Re: PA23-005 – Creekside PRD – Technical Review 2
7808 40th Street, 7811 & 7715 40th Street NE, APNs 29050200100200,
29050200100300, and 29050200100400

The following comments are required to be addressed prior to a SEPA determination being issued:

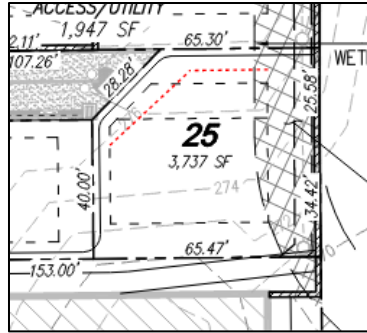
2. For Net Project Area calculations, only the non-transferrable critical areas should be removed. This would be the stream channel only on this site. Please revise the calculation appropriately.

**DENSITY, DIMENSION AND PARKING
PER MMC 22G.080.080**

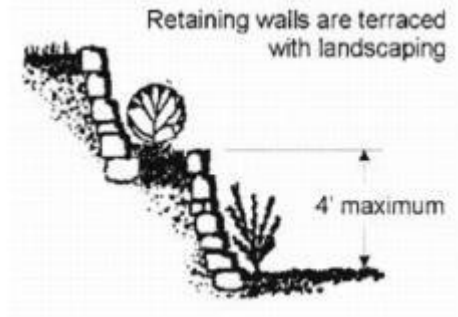
4. Bulk and dimensional standards for a PRD are outlined in [MMC 22G.080.080](#). The table on sheet 2 of the Preliminary Site plan indicates a lot size that does not meet the minimum; see below.

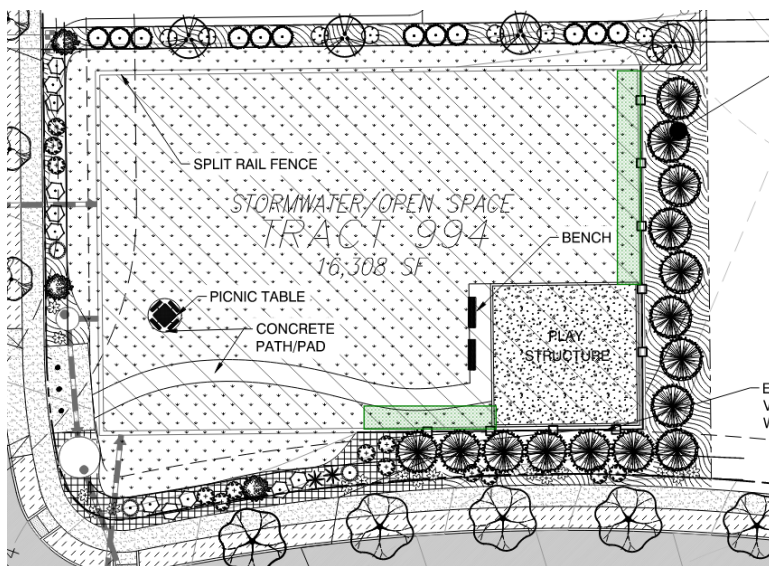
6. Pursuant to MMC 22D.050.030(4)(e), retaining walls taller than four feet shall be terraced so that no individual segment is taller than four feet. Walls between lots 44 and 49, 27 and 24, along the southern boundary of lots 29-35, adjacent to 44th Street, and in scattered other locations, exceeding four feet will be required to meet the terracing requirements below. Lots directly abutting the wetland *and not visible* from adjacent lots or roadways are not required to meet these standards. Compliance will be verified during civil construction plan review.

Tall retaining walls must be terraced with landscaping as depicted below.
